Docket Nos. 50-352
50-353

Subject: Limerick Generating Station (LGS)-Units 1&2
Open Items from NRC Draft Safety Evaluation
Report (DSER) - Structural Engineering
Branch (SEB)

ENCLOSURE 1
Response to LGS DSER-SEB Open Item Numbers 1, 4, 8, and 9

WALL ON LINE 19.4 (BETWEEN EL 200'-0" & 217'-0") LOOKING WEST

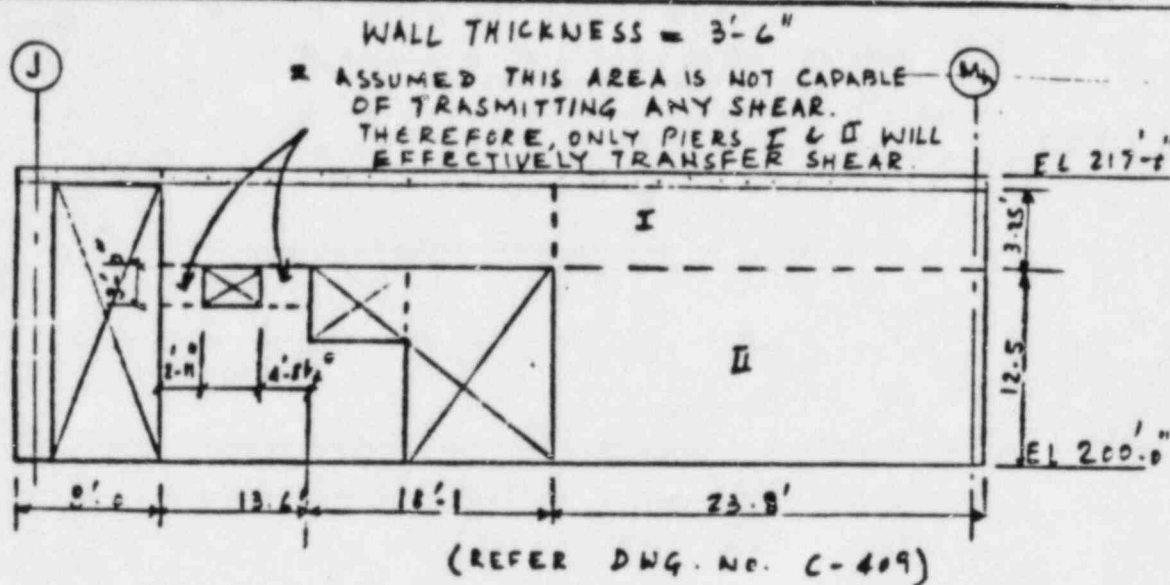
During a structural design audit of the reactor/control building calculations by the staff, it was learned that the horizontal load transfer assumptions between the roof/floor diaphragms, the shear walls and the foundation were not clear. To verify the logic of the load path assumptions relied upon, the applicant should provide a description of the assumptions made and verification of agreement between the calculations and the assumptions. The staff considers this to be a confirmatory item.

FOR WALL @ 19.4

MAX SHEAR STRESS, PIER II = 462 psi

$$\text{VERT REINF FOR LOCAL BENDING} = \frac{M}{\phi f_y (d - a/2)}$$

$$= \frac{4709 \times 10^3}{60.5 \times 54 \times 23.8} = 0.66 \text{ in}^2/\text{ft}$$

$$\text{DUE TO TENSILE FORCE} = \frac{107 \times 42 \times 12}{0.9 \times 60000} = 1.0 \text{ in}^2/\text{ft}$$

$$\text{TOTAL REINF. REQD.} = 0.66 + 1.0 = 1.66 \text{ in}^2/\text{ft} <$$

PROVIDED #9 @ 6" EF 4.0 in²/ft
O.K.
